OASIS ON BALLOU 2015 Photos

Codman Square NDC is pleased to submit the enclosed OASIS on Ballou Urban Farm Year 2 site design plan for Comprehensive Farm Review. Year two plans at Ballou consist of two changes:

OASIS on Ballou Urban Farm Year 2 Site Design Clarifications and Response to Initial CFR Comments

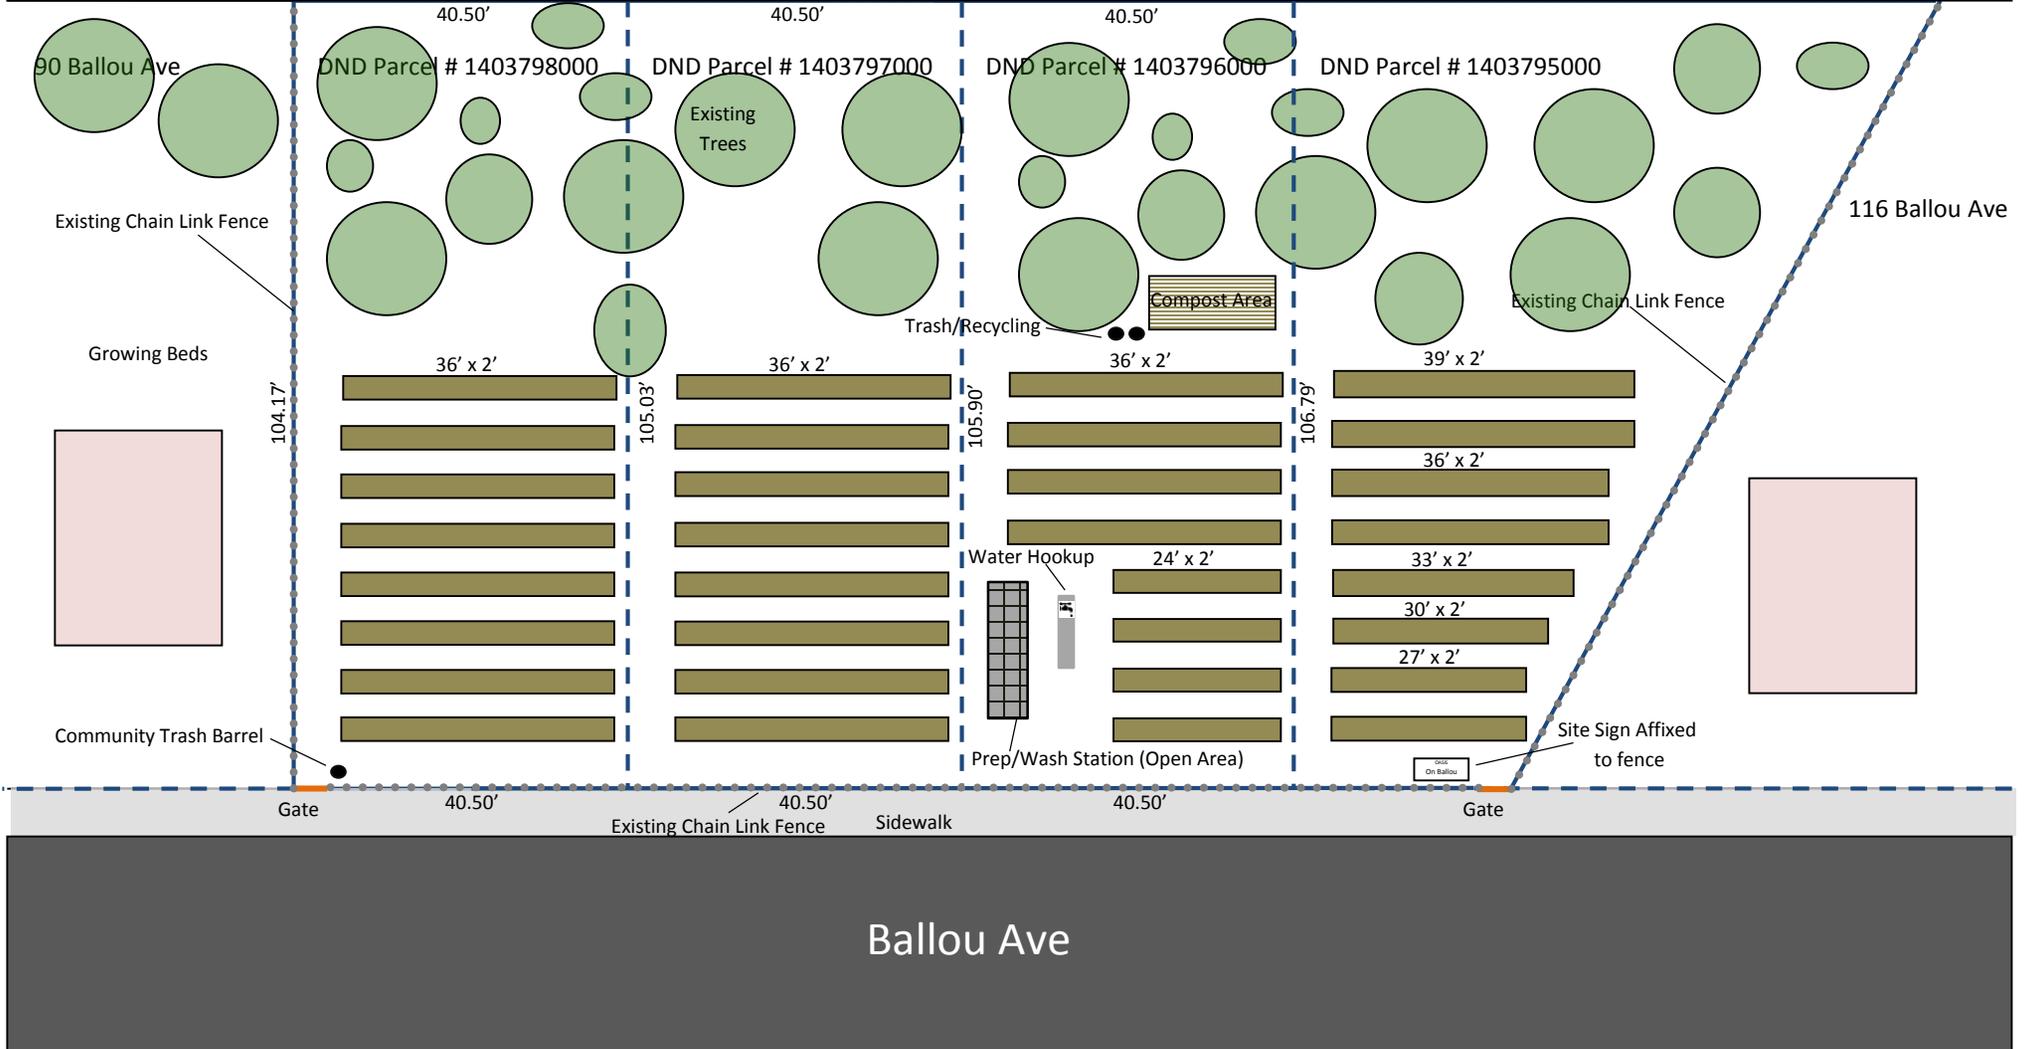
Per our review of your initial questions on our Year 2 Site Design Plans, please see the following clarifications:

The Trash and recycling cans* were used for the farm purposes. These were standard Rubbermaid hard plastic bins. They are free-standing, chained to each other and placed by the composting area. We removed them at the end of the season and stored in our office basement, generally had little use given that there was minimal trash or recyclables created by the farming activities. They will be reinstalled when on-site operations resume per site plans.

A **community trash barrel** was installed as previously agreed at the front of the site along the fence to help discourage littering on the sidewalk/street. This is a decorated corrugated aluminum can adopted from a neighborhood "Clean City / Healthy City community trash barrel campaign.

The **site gates are not permanent** and neither is the **exiting chain link fence**. As stated last year, existing chain link fence will remain in place until final phase preparations are more defined and final site access points are defined. Current access points work for the current site uses. We are pursuing funding and have identified an architect to facilitate a community charrette for a more thematic and permanent fence that reflects community vision for Ballou.

The **prep station** at this point is nothing more than an open area, providing space for crates/bins with produce harvested can be kept until moved off site. This area was originally prepped for production rows, but the water hook-up plans broke up that set of rows. It made sense to have an open area near the water source for any produce washing. There are no tables or hard surfaces planned at this point.

- Note: The **trash and recycling in the left, front part of the property** is an oversight on our part. I asked a colleague who helped with last year's plan to create new ones with the added rows. He accessed the original version that he had on file and not the one that was revised based on your initial comments from last year.
